STAFF REPORT
COMMUNITY DEVELOPMENT DEPARTMENT

HEARING DATE: October 22, 2020
 Continued from July 16, August 20, September 17, 2020

TO: Planning & Zoning Commission

SUBJECT: H-2020-0047
 Prescott Ridge – AZ, PP, PS, ALT

E. Qualified Open Space Exhibit & Site Amenities (dated: 8/26/20)

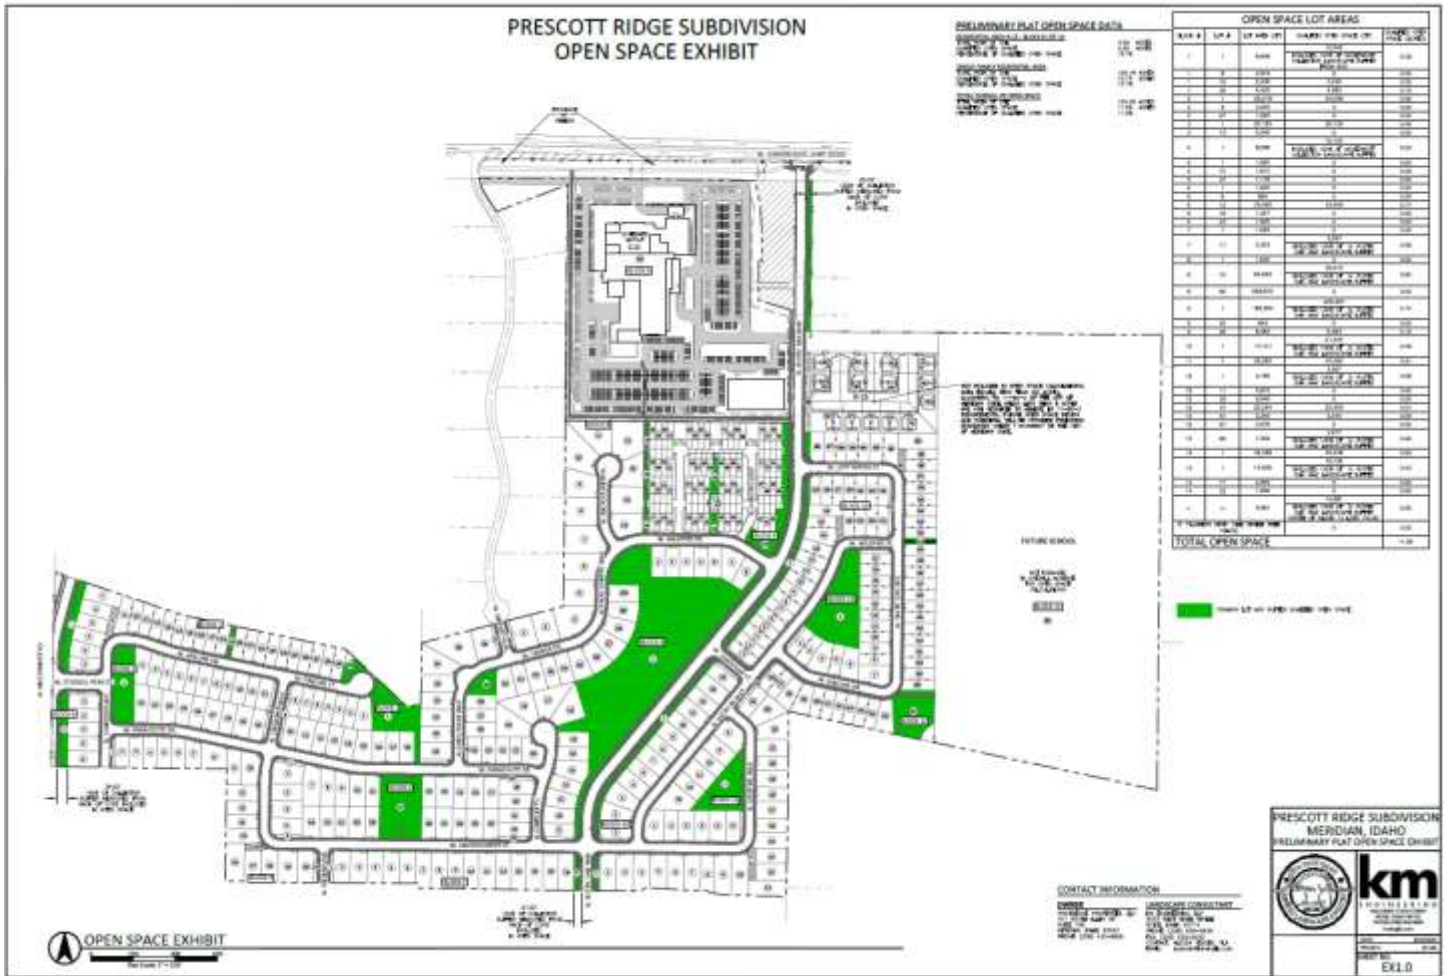
- k. If a dog park is proposed on Lot 1, Block 2, demonstrate compliance with the standards listed in UDC 11-3G-3C.1h.
 - l. Depict a small tot lot on Lot 12, Block 6 rather than a large tot lot, consistent with that shown on the site amenities plan.

F. Parking Plan (dated: 4/8/20) – NOT APPROVED (*Parking for townhome portion needs to be revised*)

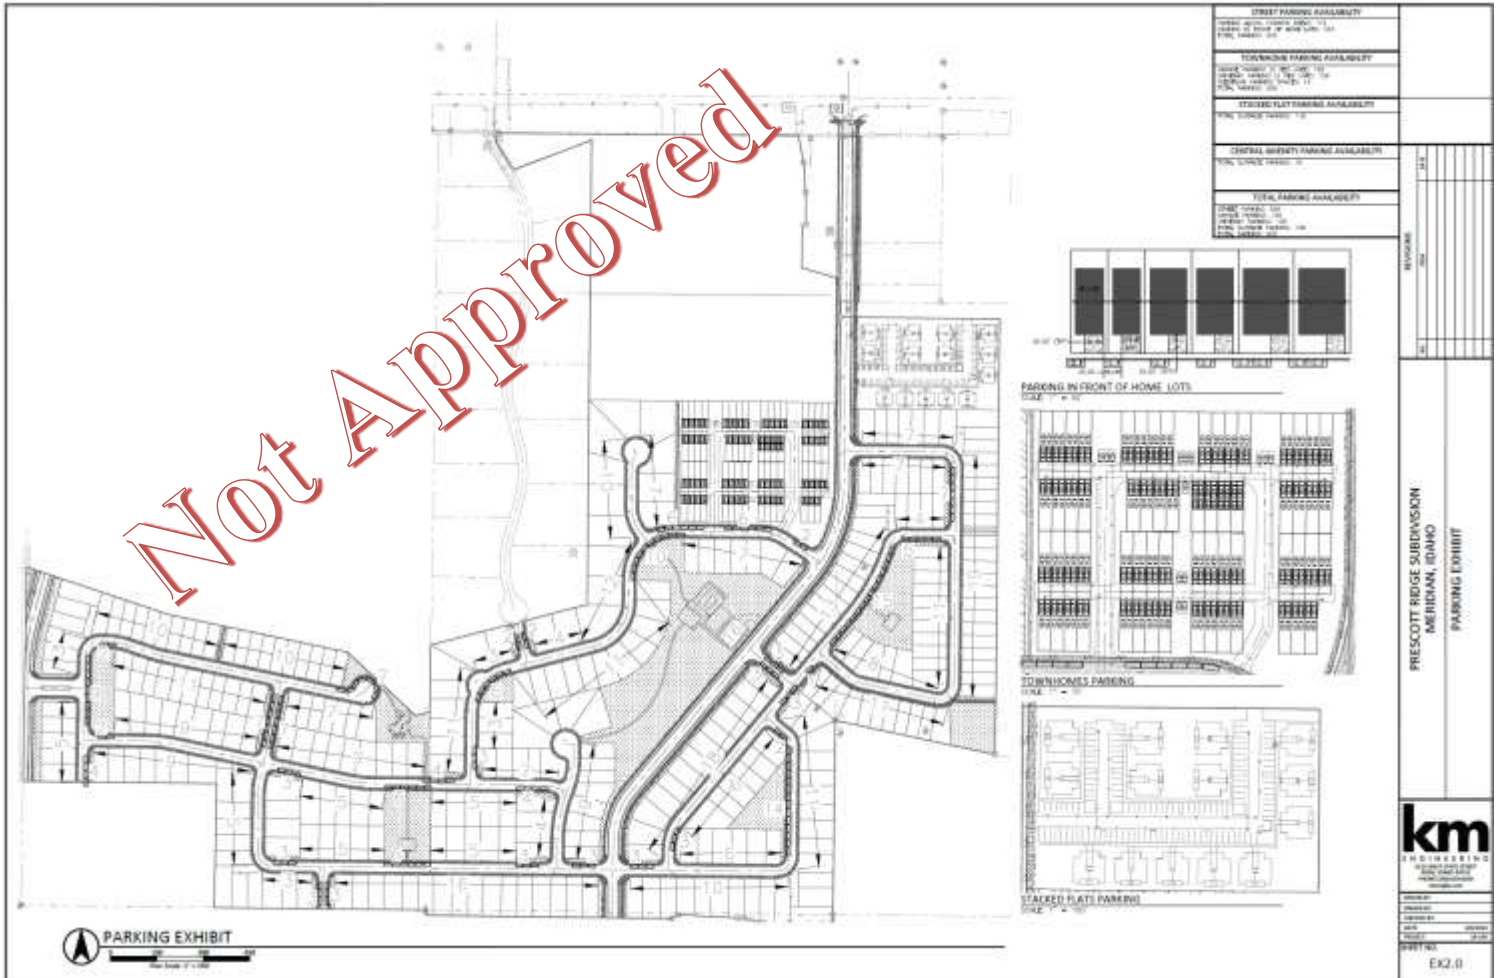
(i.e. one structure on one property with 3 or more dwelling units) with townhome style units might be a development option for this area. A revised parking plan should be submitted for this area as well that provides for adequate guest parking above the minimum UDC standards (Table 11-3C-6) to serve this portion of the development. A revised concept plan and parking plan should be submitted prior to or at the Commission hearing for review and a revised plat should be submitted at least 10 days prior to the City Council hearing that reflects this modification.

5. Off-street parking is required to be provided for residential uses in accord with the standards listed in [UDC Table 11-3C-6](#) and for commercial uses in accord with the standards listed in 11-3C-6B; bicycle parking is required in commercial districts as set forth in UDC 11-3C-6G per the standards listed in UDC 11-3C-5C. **A revised parking plan shall be submitted prior to or at the Commission hearing for the townhome portion of the development that reflects the changes noted above in condition #A.2f and that provides for adequate guest parking to serve this portion of the development.**
